RE: 716 Site Investigation And Remedial Action Options Report
Bear Development, LLC
Filer & Stowell Property 147 East Becher Street Milwaukee, Wisconsin
BRRTS 02-41-589088

March 29, 2022
Ramboll Project 1690023383

Please find the following response to the DNR's March 21, 2022, email requesting additional information for the Beta-Becher Acquisition Co, LLC (BRRTS case 02-41-589088). The DNR's questions are presented below followed by Ramboll's response (in blue type).

FIGURE 1

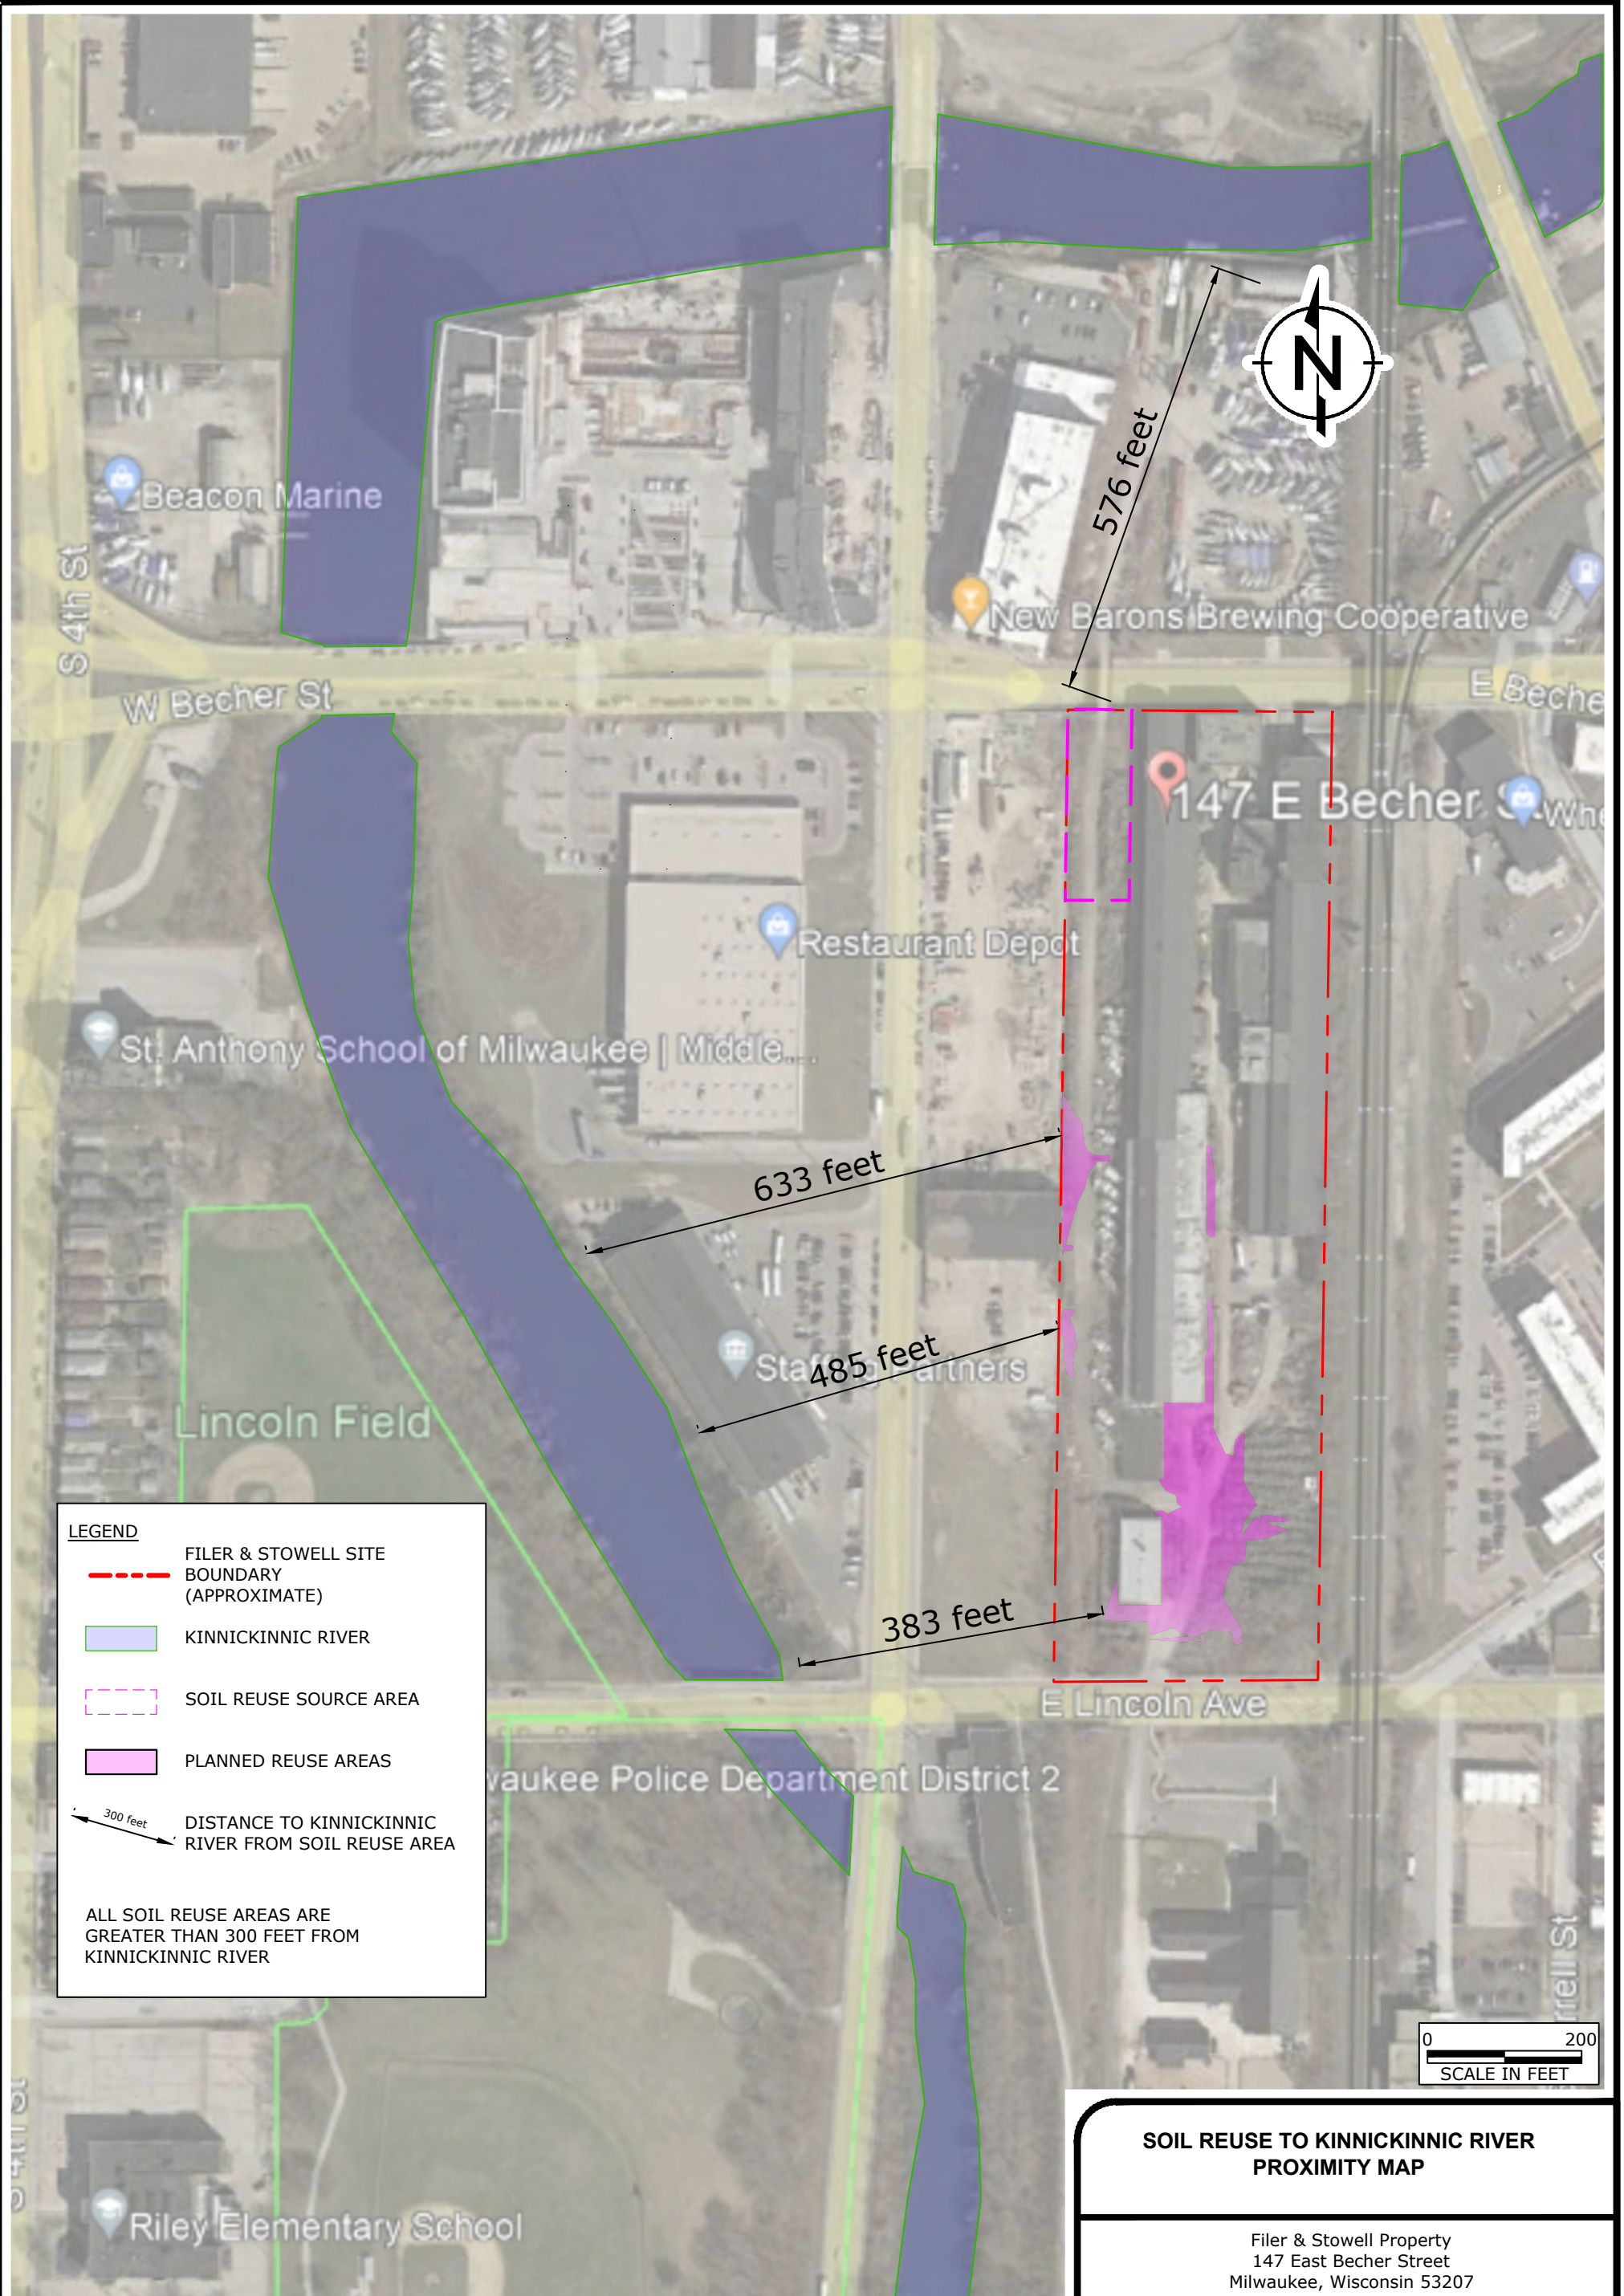
1. *Confirm whether the Kinnickinnic River is within 300 feet of all areas on the site where soil reuse will occur. If so, then an exemption to the locational criteria presented in Wis. Admin. Code § NR 718.12(1)(c) will be required.*

The Kinnickinnic River is more than 300 feet away from all planned soil reuse areas. See **Figure 1** for the site location, planned soil reuse areas, and dimensions from planned soil reuse areas to the Kinnickinnic River. Therefore, Ramboll is not requesting a locational exemption.

ALL SOIL REUSE AREAS ARE GREATER THAN 300 FEET FROM KINNICKINNIC RIVER

FIGURE 2

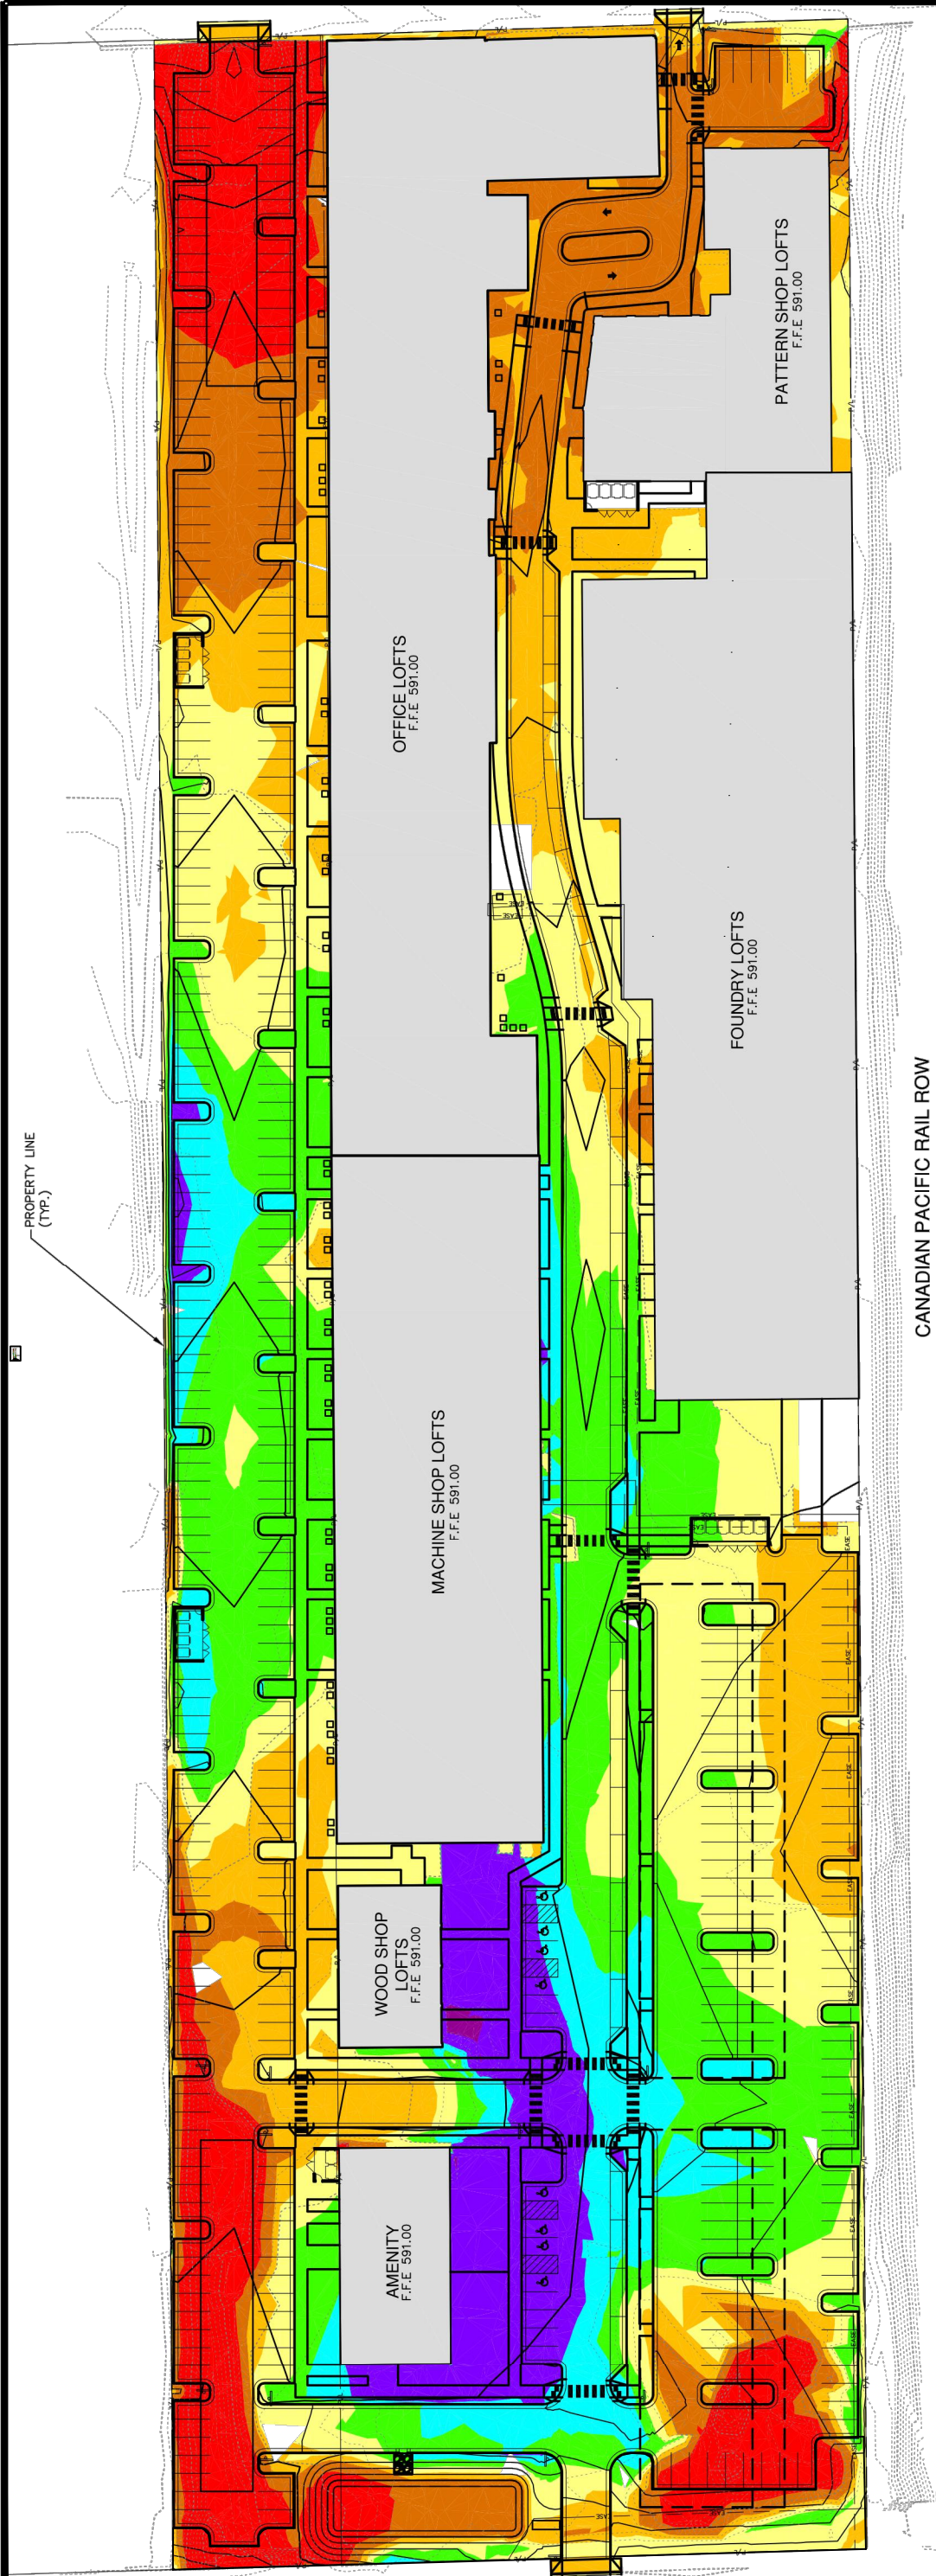
2. *Clarify whether any of the soil to be reused on the site may be placed within three feet (ft) of the highwater level. If so, then an exemption to the locational criteria presented in Wis. Admin. Code § NR 718.12(1)(c) will be required.*

The planned reuse soil will not be placed within 3 feet of the high water table. Note that the groundwater elevation in Wisconsin Administrative Code (WAC) Chapter NR 141 groundwater monitoring well MW-2, which is located within the planned soil reuse area and has the highest groundwater elevation at the site, had groundwater elevations ranging from 4.7 to 4.8 feet below ground surface (bgs). The planned site cut and fill map illustrates that 3 to 5 feet of soil will be placed on top of this area. Therefore, the planned reuse soil will be approximately 4.7 to 4.8 feet above the highest groundwater elevation at the site and not perceived to need a locational exemption. Additionally, the soil placed here shall not pose a threat to public health, safety, welfare, or the environment, based on the soil reuse analytical results. Please find the attached **Figure 2** (Site Layout), **Figure 3** (Cut and Fill Map), and **Table 1** (Groundwater Elevations).
